ADDENDUM NO. 1

Project Designation: 16070 - JJSD #251 Harwood Elementary Addition and Remodel

For: Jefferson Joint School District No. 251

Date: April 29, 2019

SD1.1

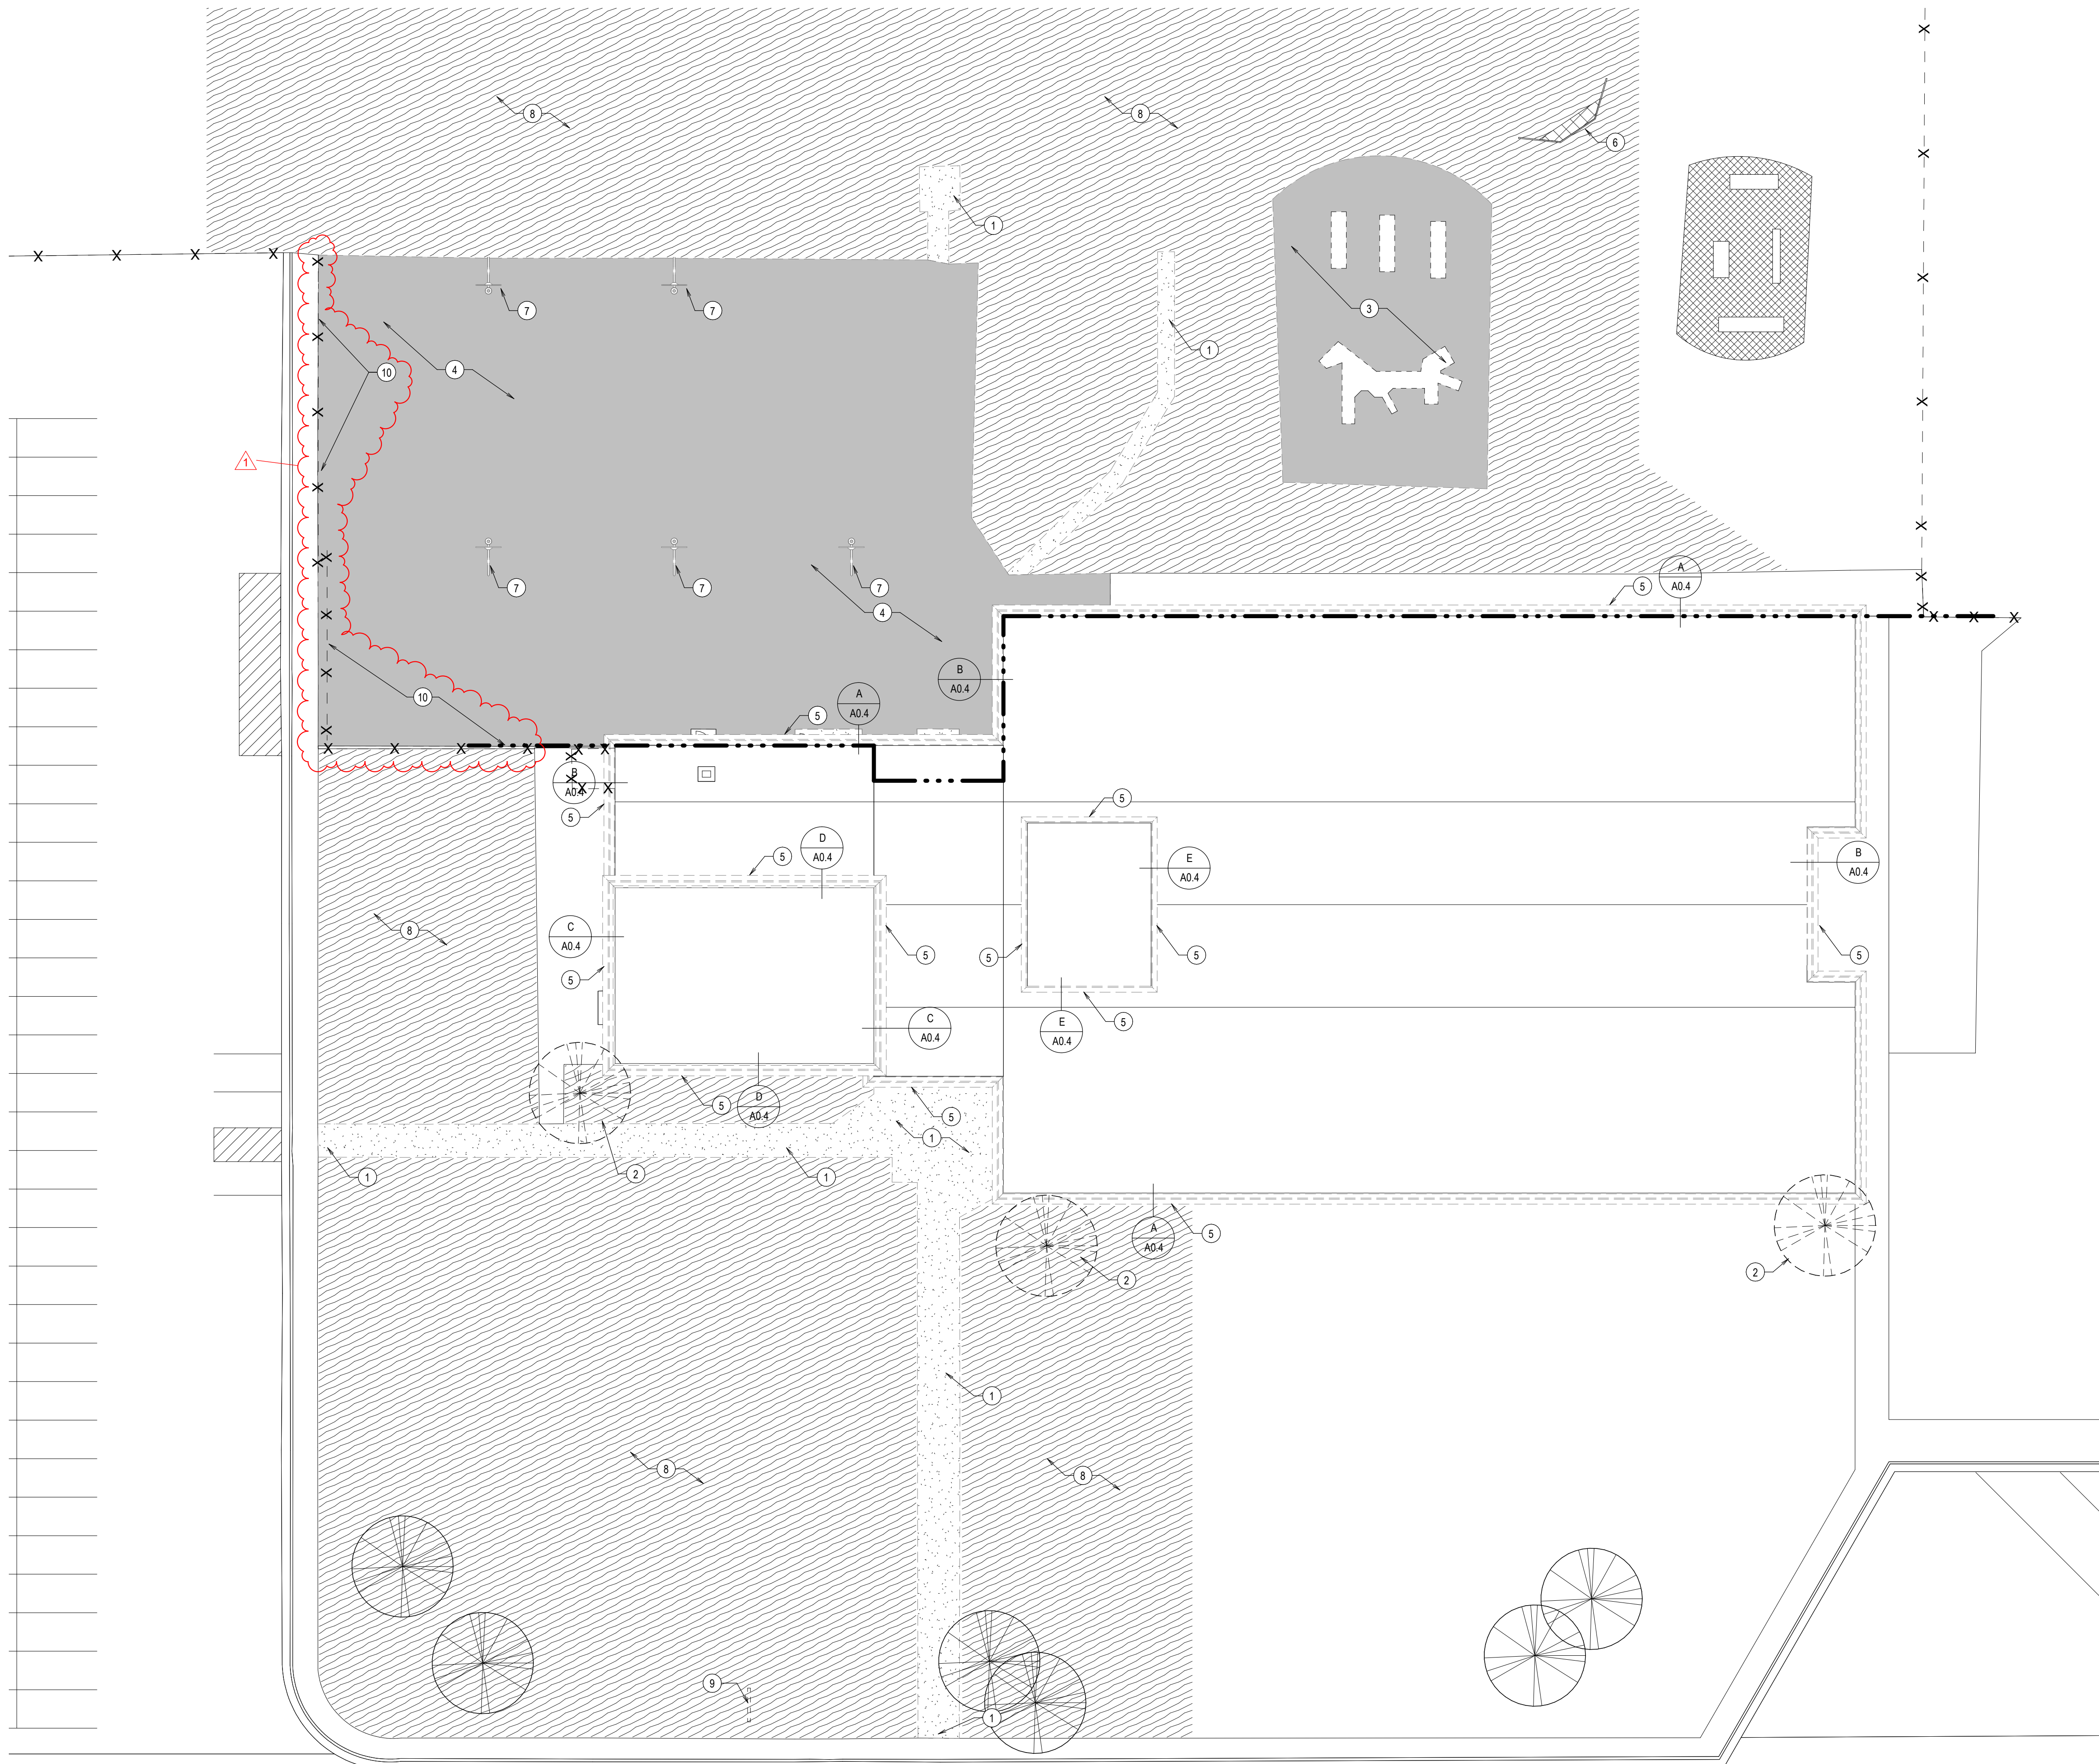
1. See revised sheet **SD1.1**
 - a. The text for Keynote #7 was changed. New fence callout. New fence section. New gate callout.
 - b. Backstop design changed.

- c. Basketball Hoops added and adjusted.
2. See revised sheet **SD1.2**
 - a. Details updated and added.
3. See revised sheet **A0.1**
 - a. Demolition Note #10 was changed. Callouts for removing the fence.

PROJECT:
SHEET TITLE: **ROOF, CEILING, AND WALL TYPES**

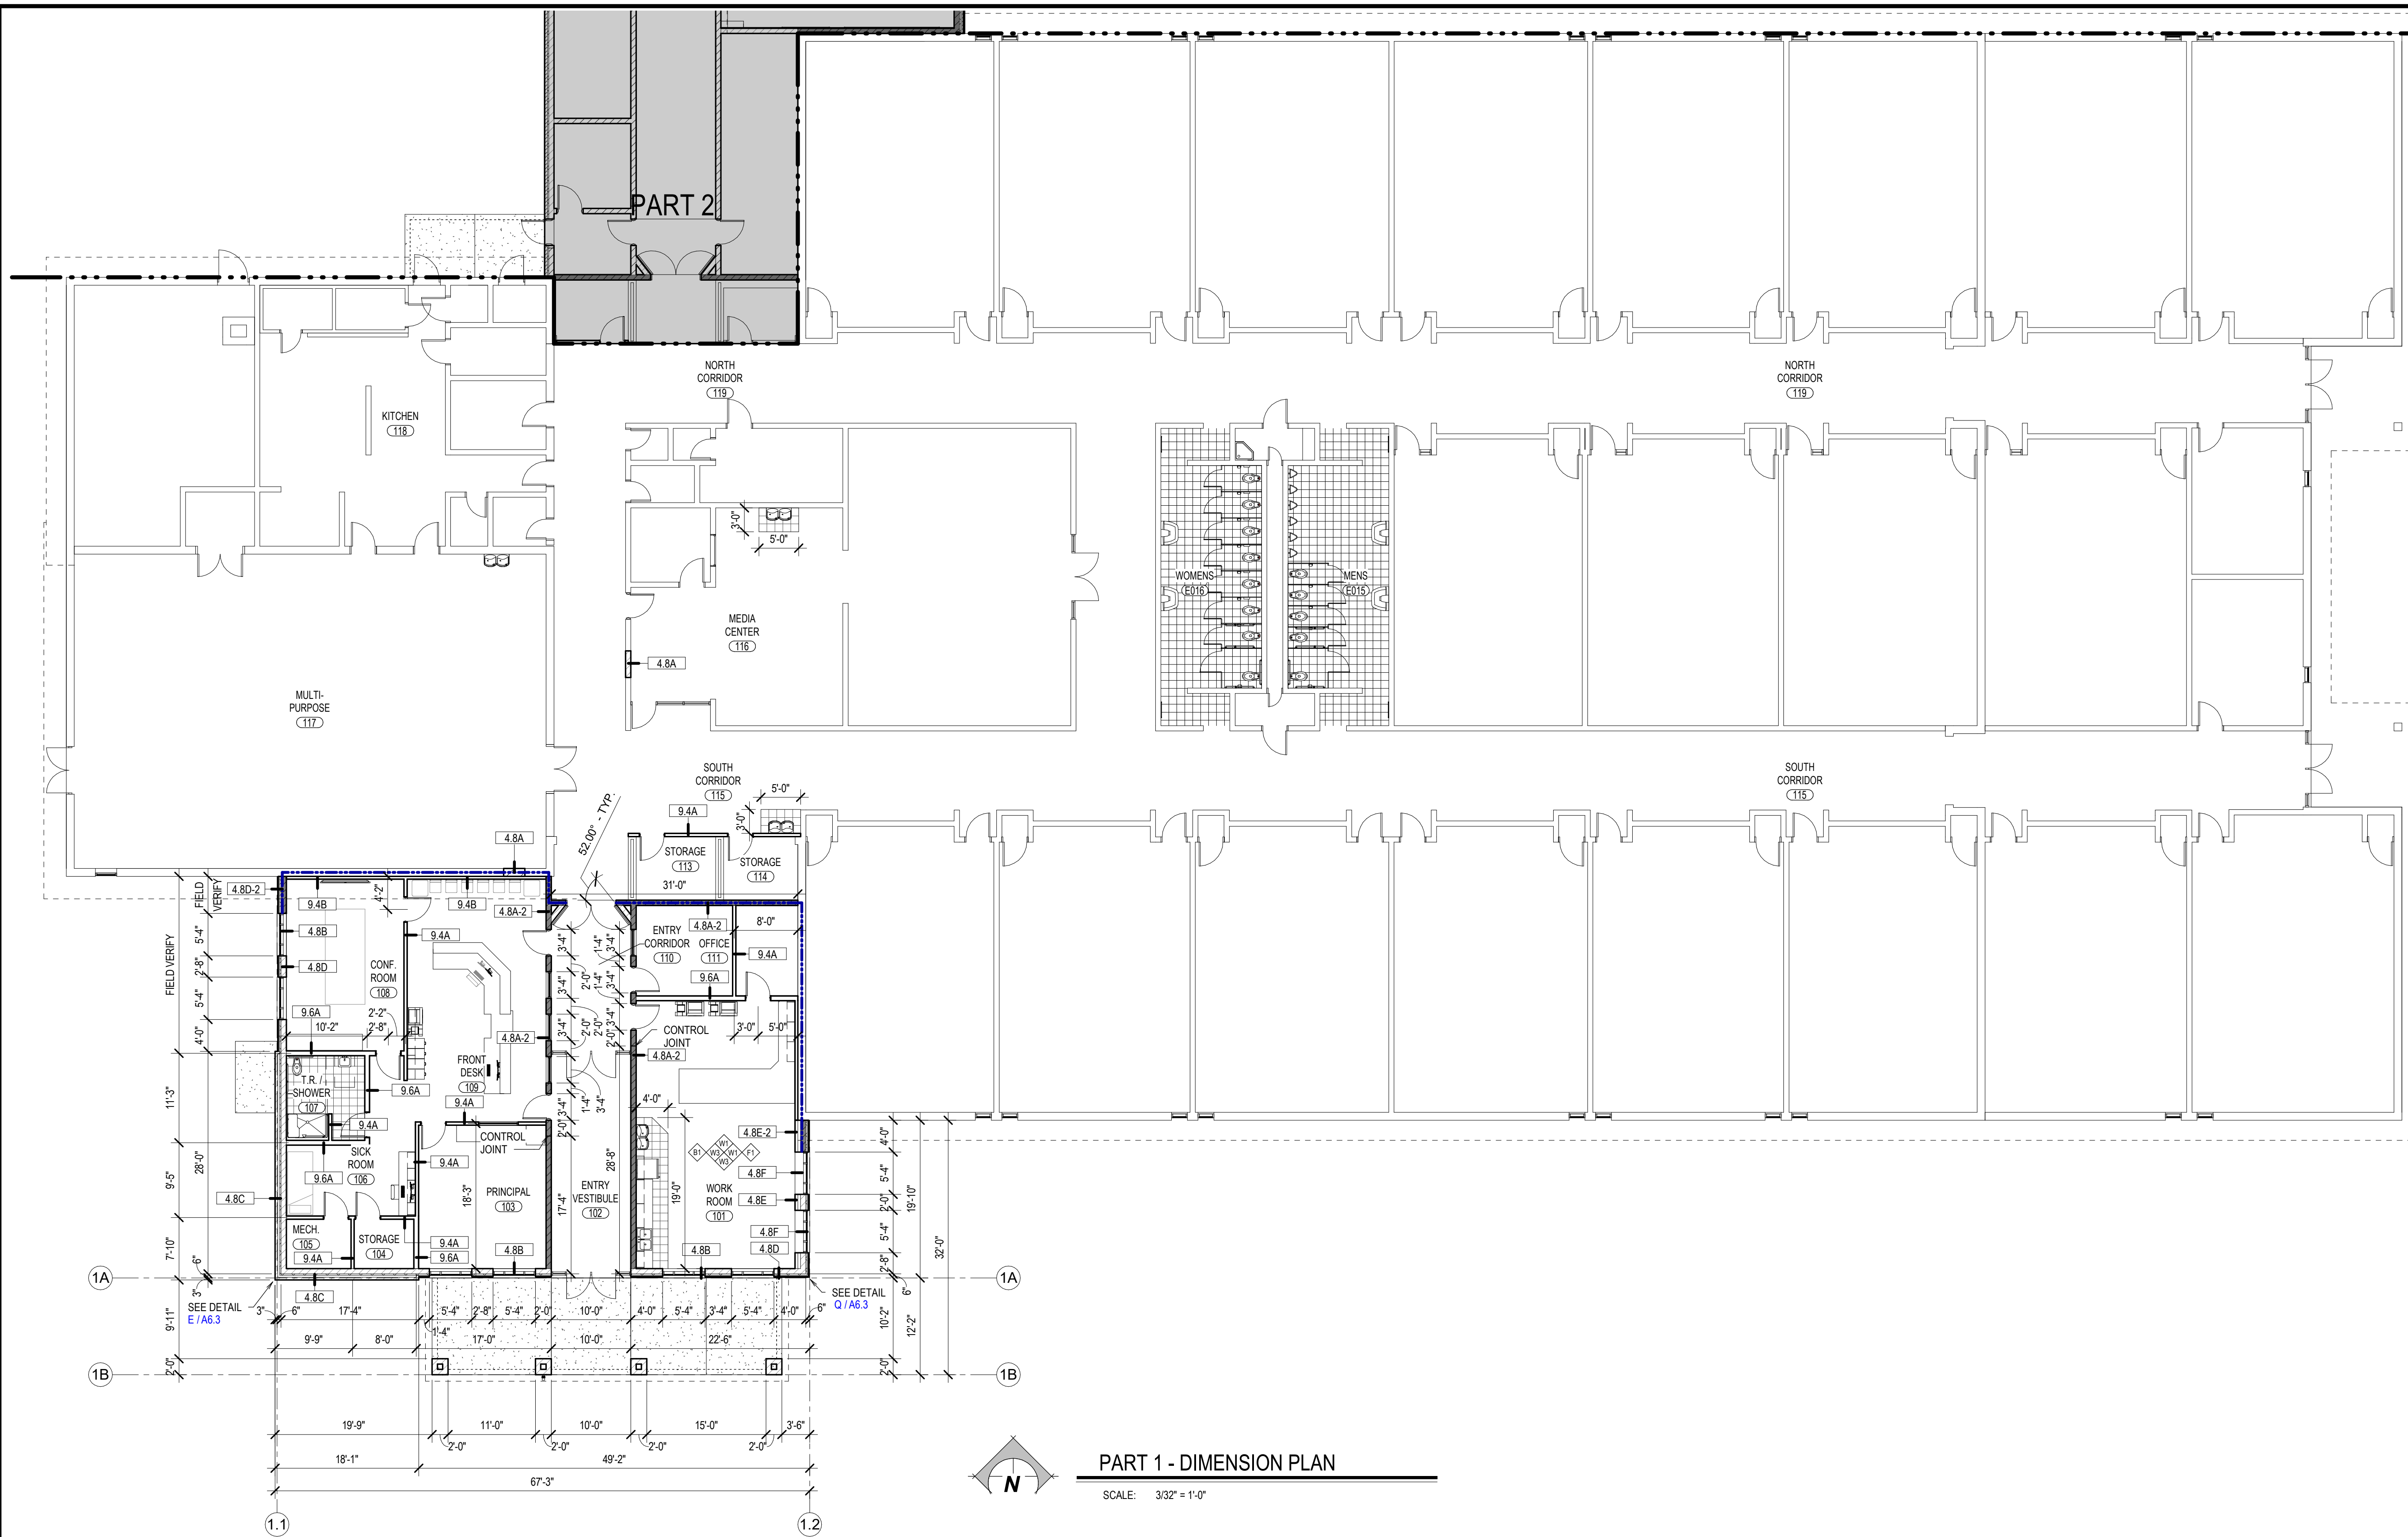
5. See revised sheet **A1.0**
 - a. Sheet title changed.
 - b. Vapor Barrier removed on the roof type. Added 1/2" Securock as an option instead of Perlite Board.

A1.3

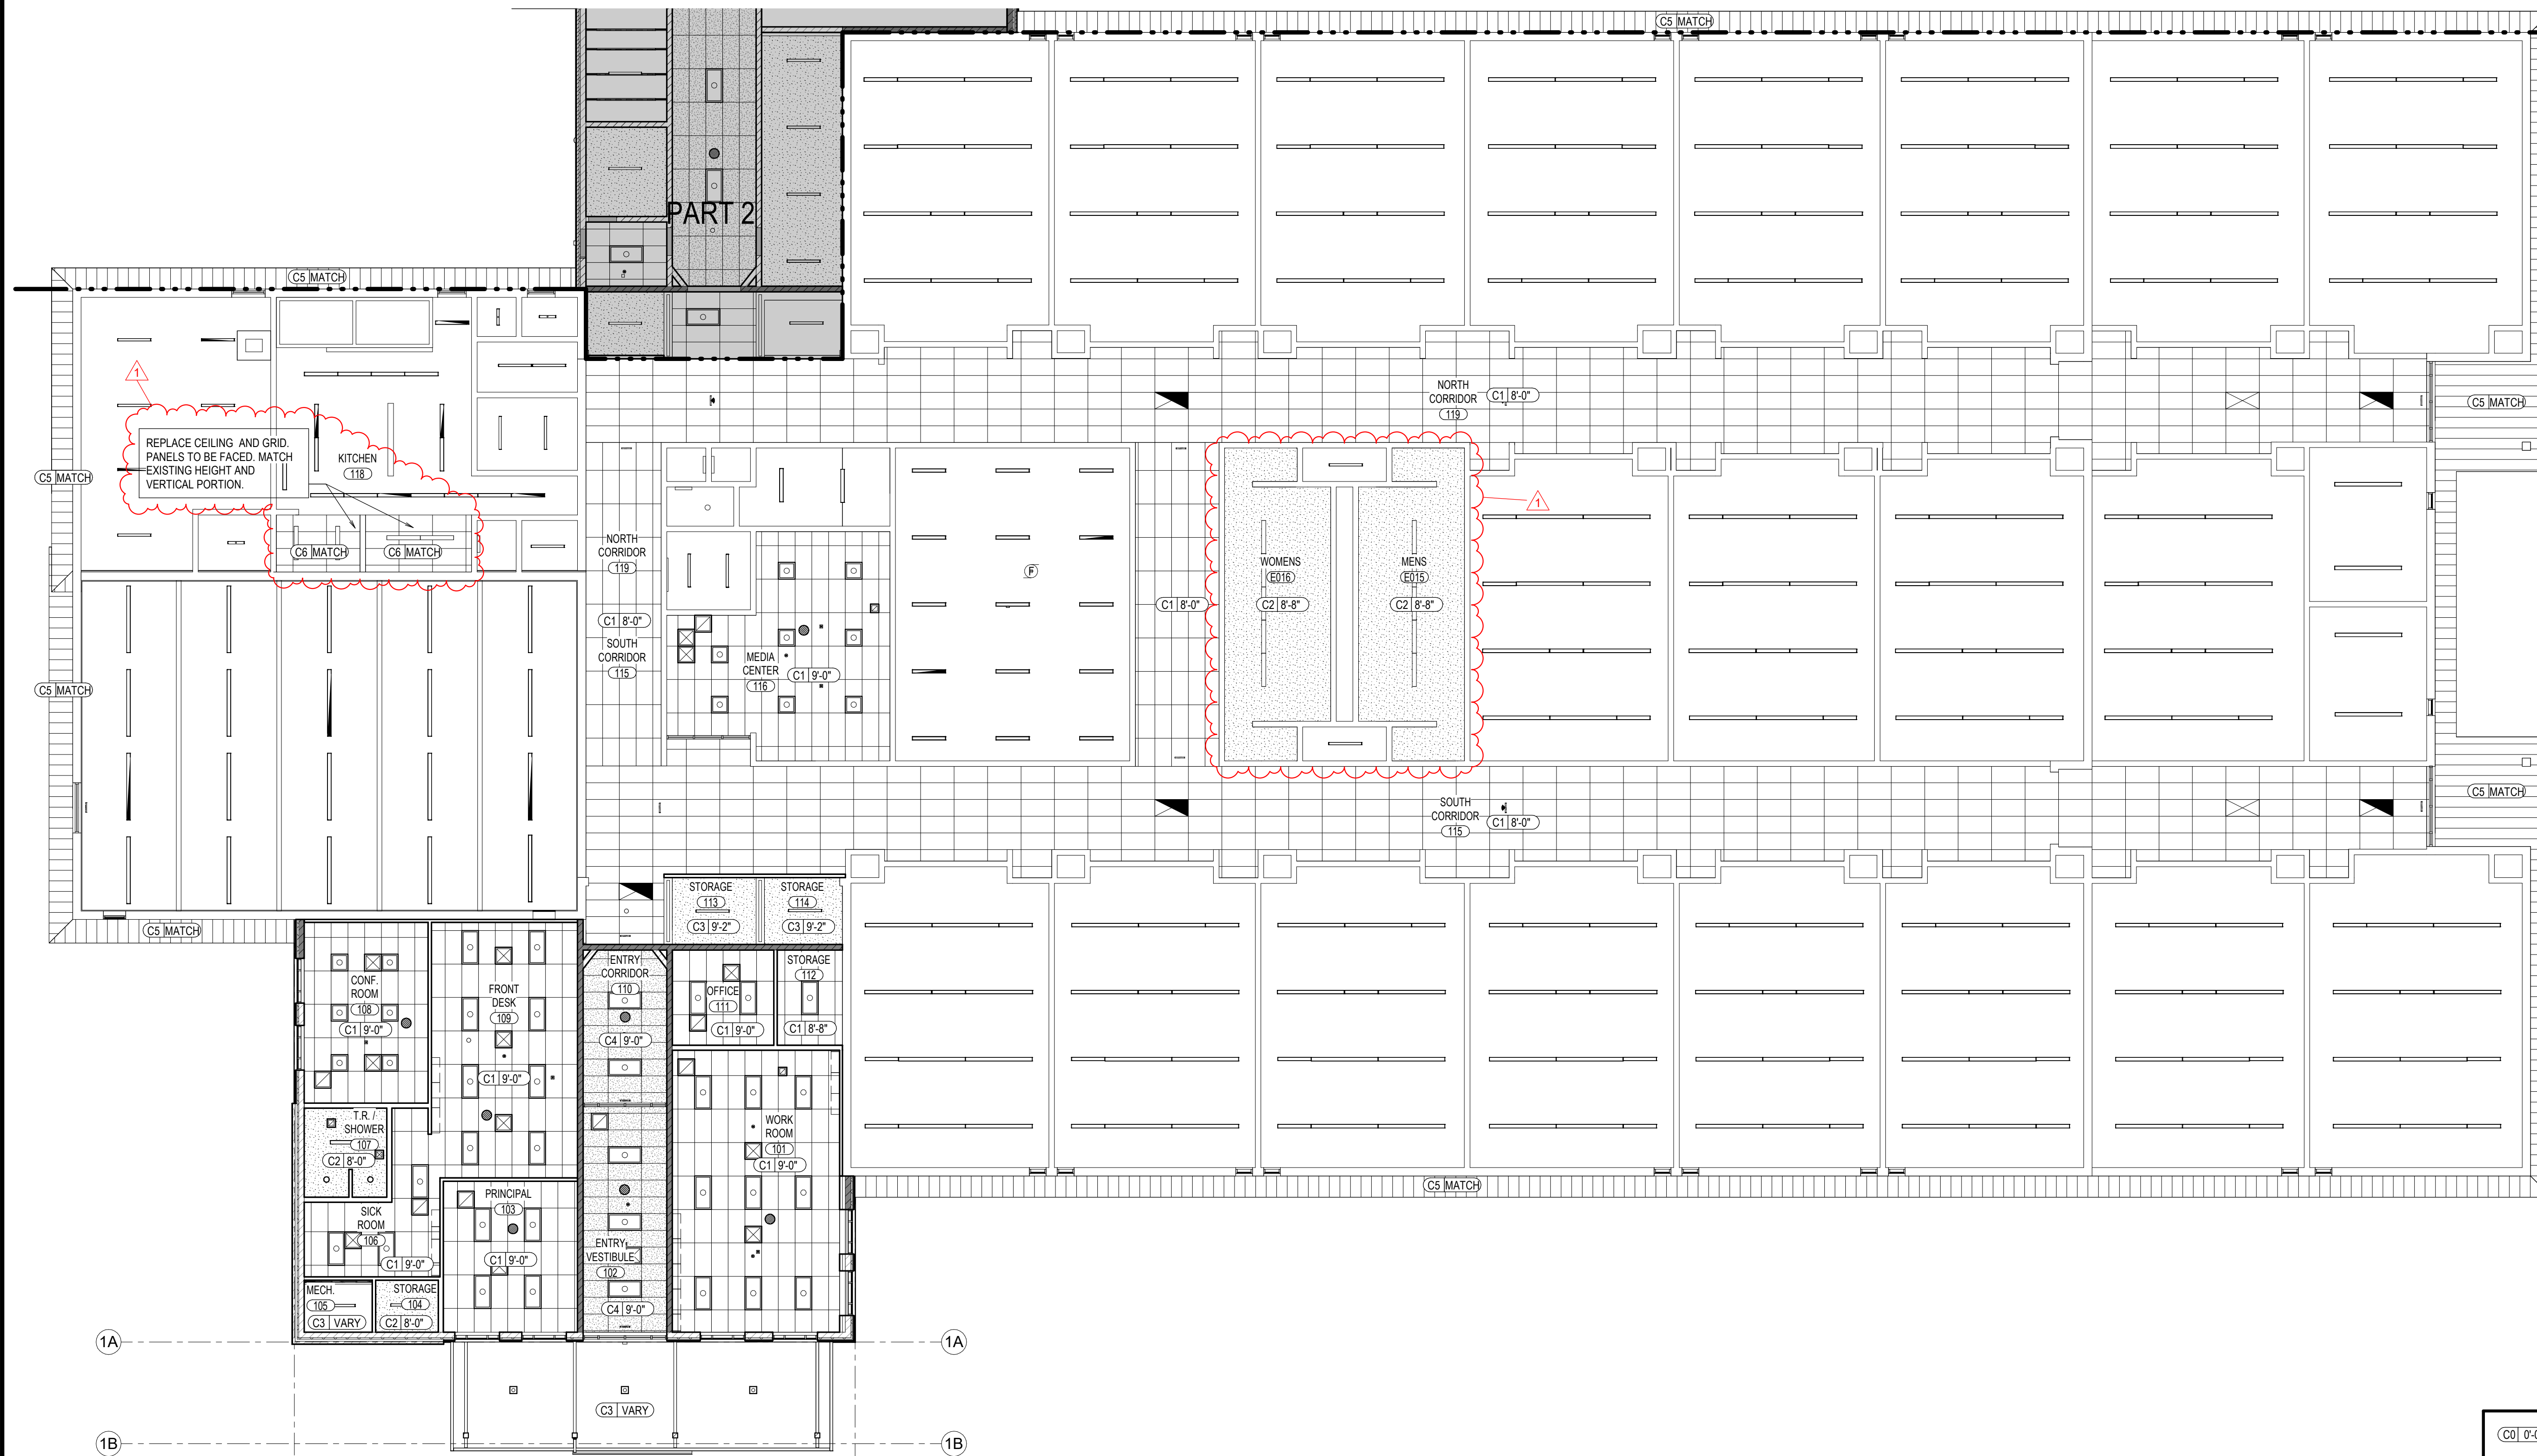
6. See revised sheet **A1.3** and **1.6**
 - a. General Note #8 added.
7. See revised sheet **A1.4**
 - a. New ceiling in existing large restrooms. Additional General Note #4 added.
